SERVICE LETTER 268

Fire Boss Scoop Tunnel & Side Cover Seal Addition

Aircraft Makes/Model(s):	Aircraft Makes/Model(s): Float Model(s):		By: MAS
Air Tractor	10000A -	Part Number: 1012757	Approved:DRH
AT-802A & AT-802		Date: 5/14/2025	Revision: B

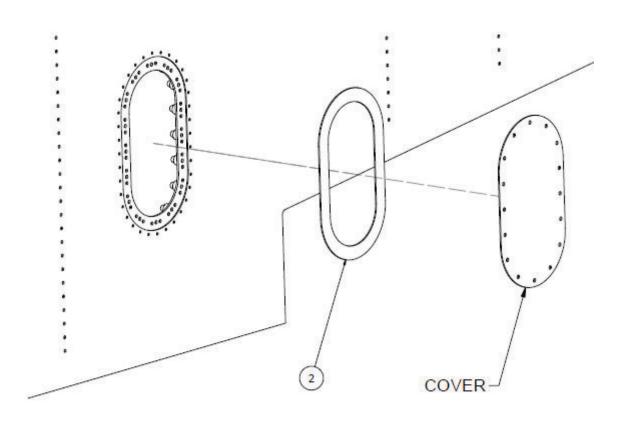
Side Cover

- 1. Remove hardware and side cover.
- 2. Clean Sealant from side cover.
- 3. Apply gasket 1012638 to inner facing side of cover.

- 4. Using scribe or similar, puncture each bolt hole to allow fastener installation.
- 5. Reinstall side cover using existing fasteners.

Scoop Tunnel

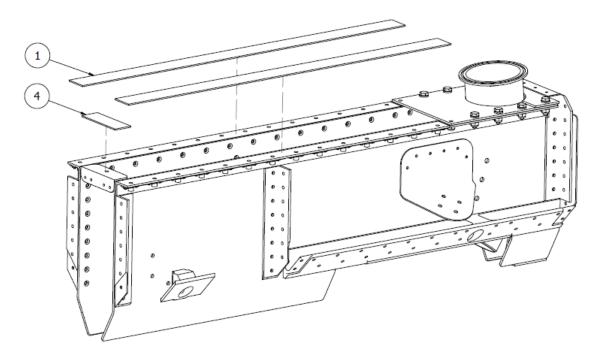
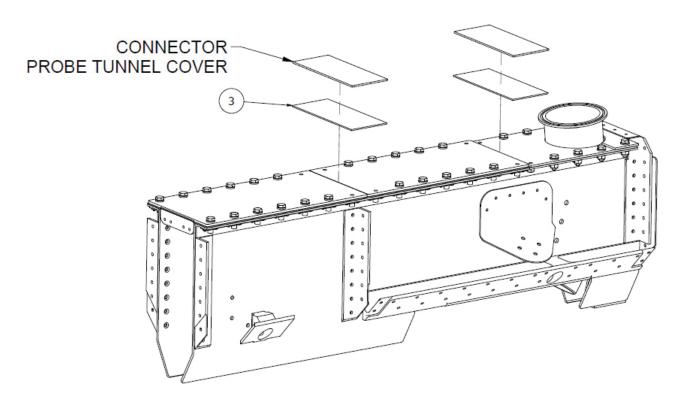
- 1. Access scoop tunnel through aft panel in foam/baggage compartment.
- 2. Remove hardware and covers on top of scoop tunnel.
- 3. Clean sealant from covers and top and bottom of flanges.
- 4. Apply gaskets 1012637 and 1012848 to top of scoop tunnel.

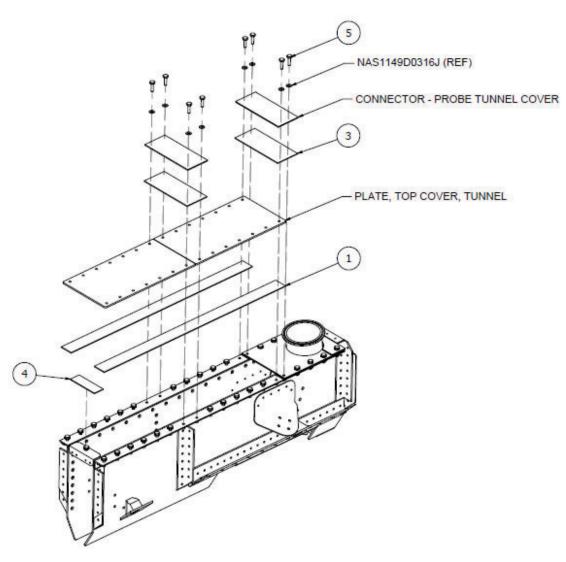
- 5. Using scribe or similar, puncture each bolt hole to allow fastener installation.
- 6. Apply gasket 1012639 to inner facing probe tunnel cover connector.

7. Reinstall tunnel covers, replacing the AN3-5A fasteners used on the probe tunnel cover connector with AN3-6A fasteners included in kit.
